SITE PROBLEM
REPORT TRANSMITTAL

FILE: 13-5-322
CONTRACT NO: 620-00 05
SPR 322 REV. 1
TITLE LOW PRESS.
LEVEL FOLLOWING
REACTOR TRIP
DATE: 6-25-76

SITE PROBLEM REPORT

TITLE LOW PRESSURIZER LEVEL FOLLOWING REACTOR TRIP

Generator Trip Test From 100% 2-13-72

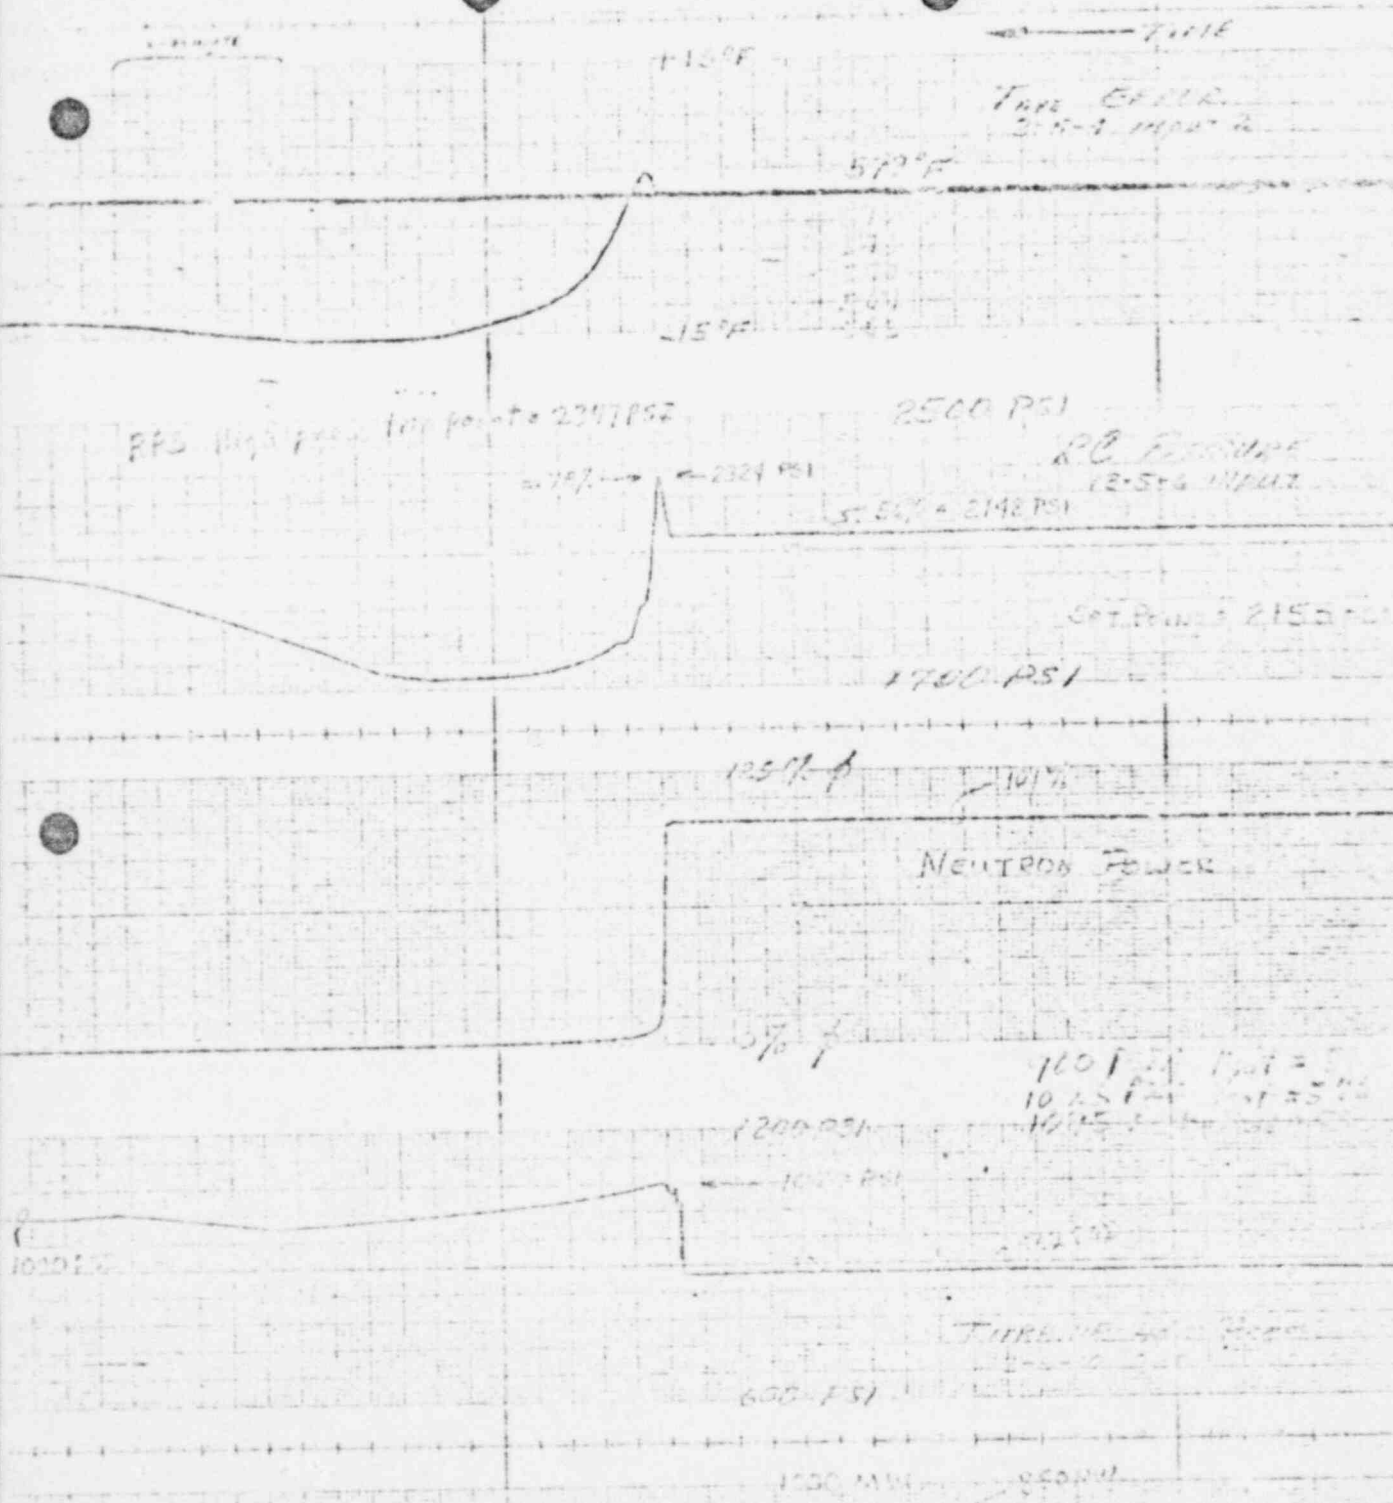
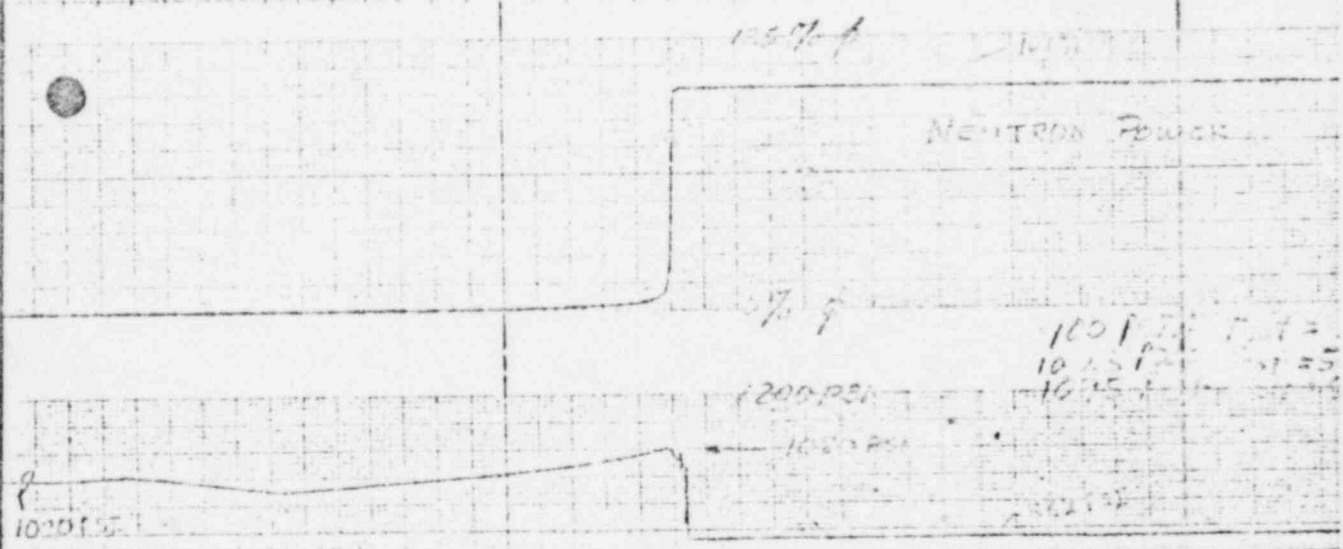
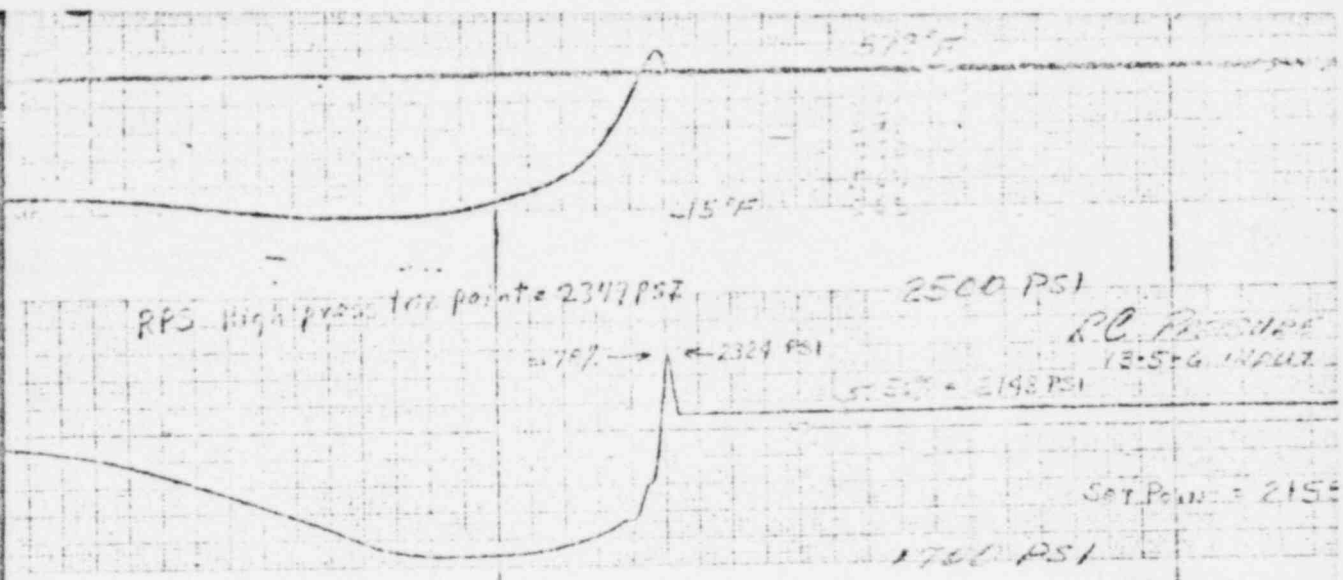
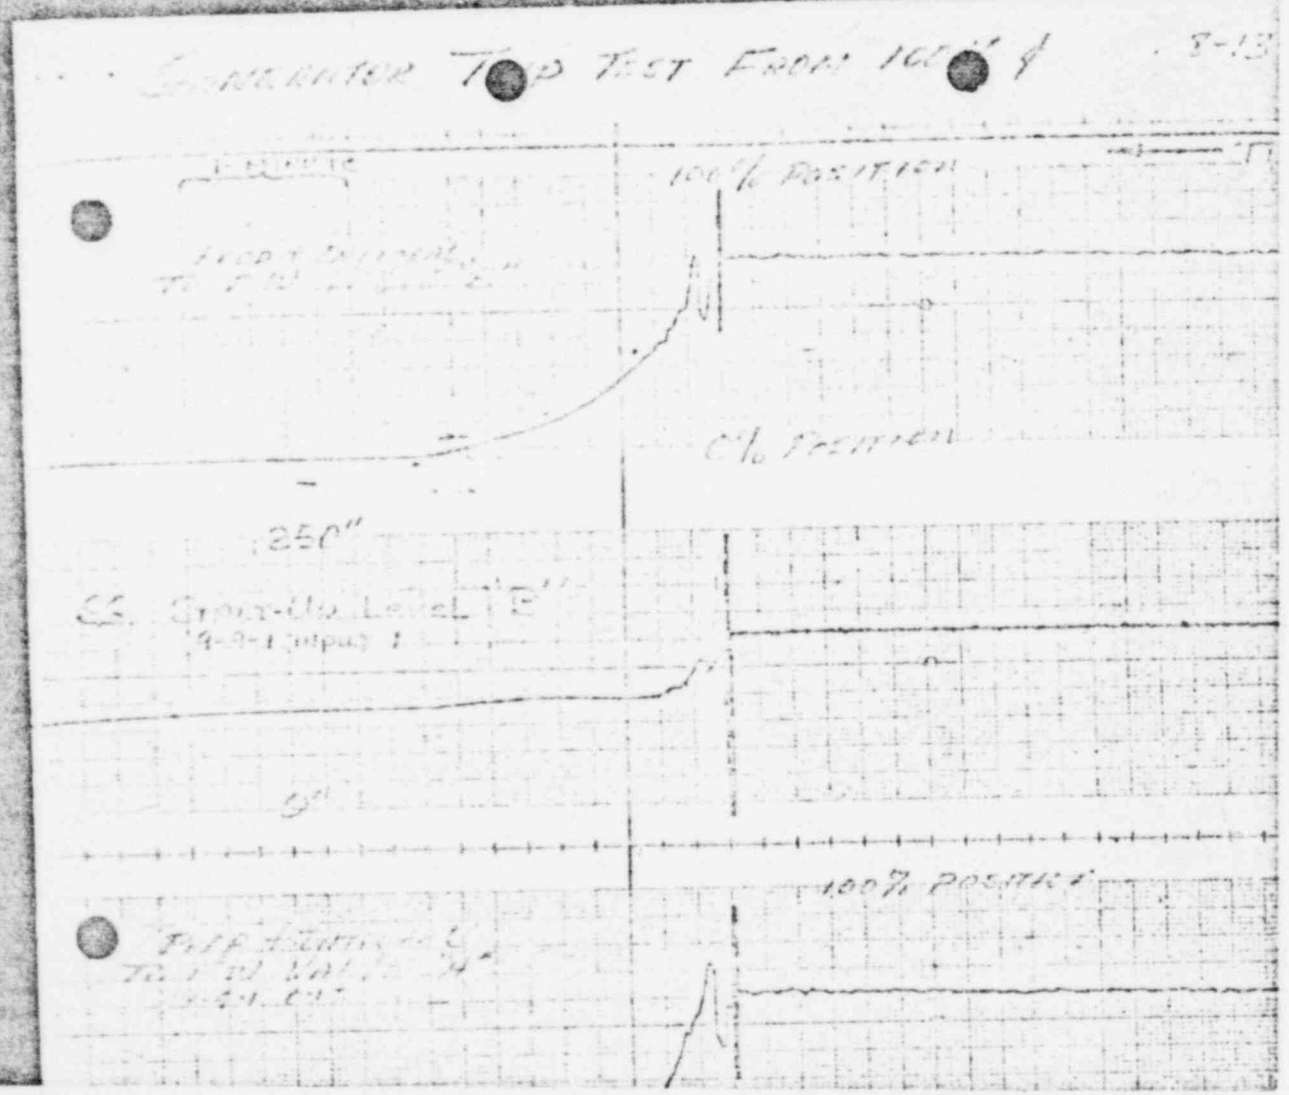
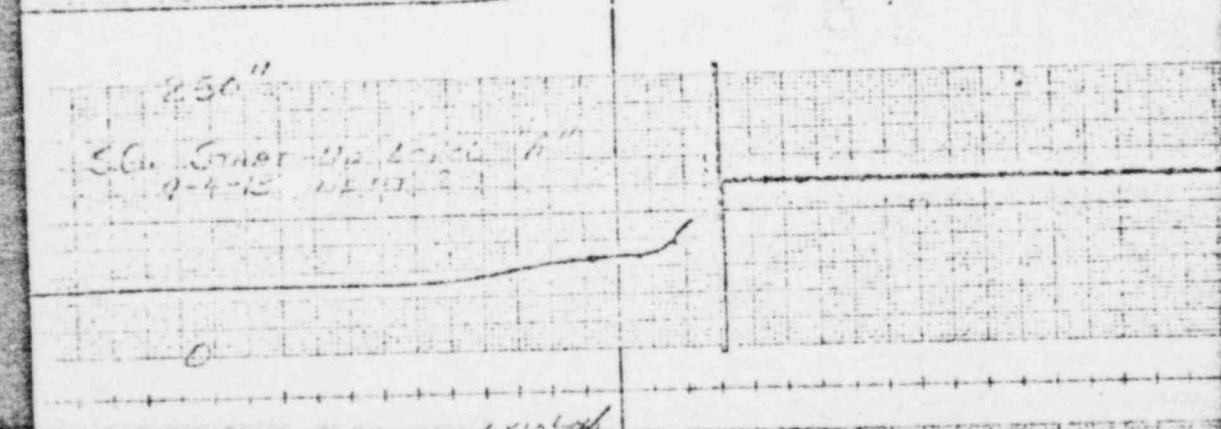
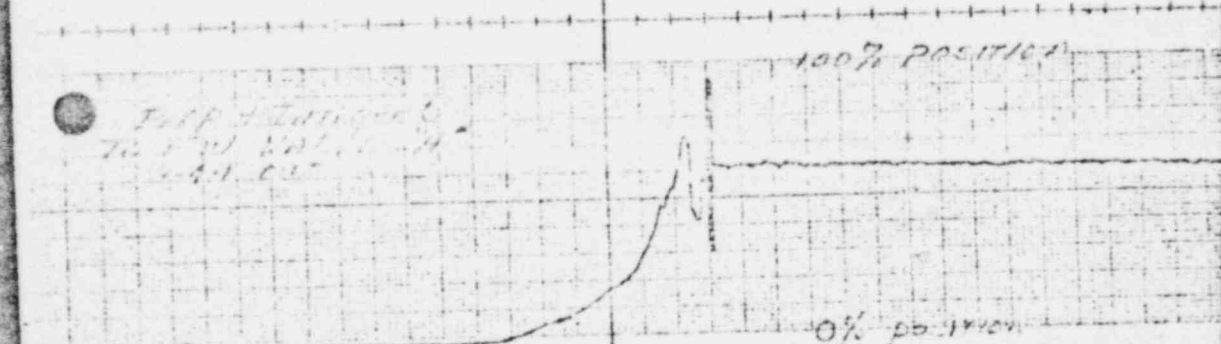
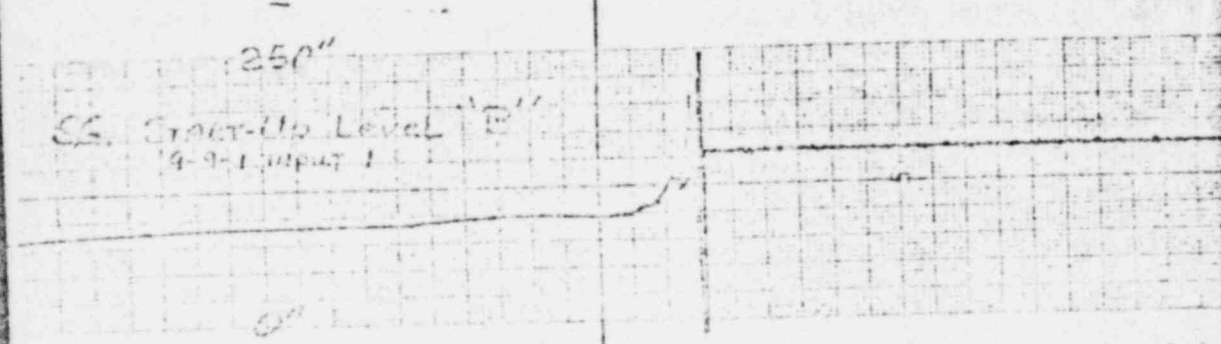
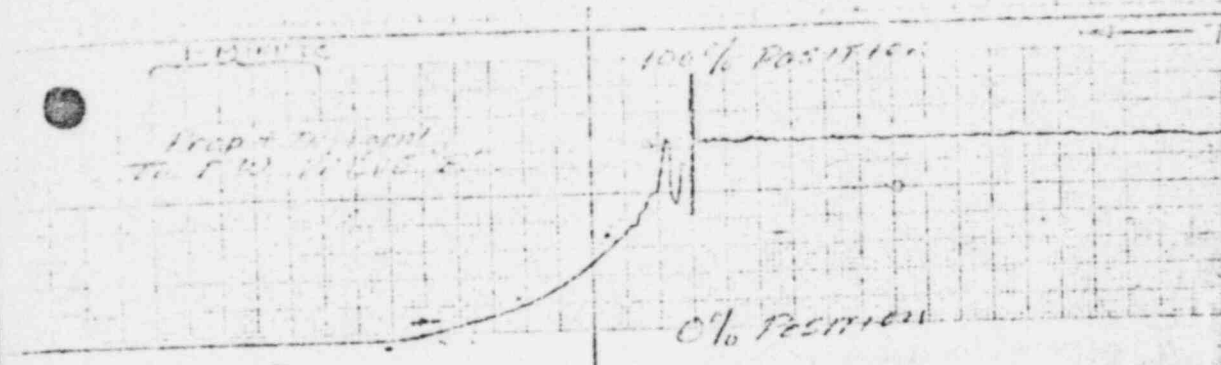
Attached please find charts recorded during a generator trip test conducted 8-13-74 which resulted in a reactor trip. From these charts and table 1 it can be noted that while there was flow through the line there was a pressure drop i.e., SG pressure is 30 psi higher than THP, immediately after the trip with no pressure drop due to flow the pressures equalized. For the next 3.5 min. the SG pressure is less than THP. Also note the waves in the SG pressure recorded during the first minute are not present in the THP pressure. These conditions seem to be a good indication that the check valves did close.

Investigation
should be
conducted
w/

20%
Should not
come back
up
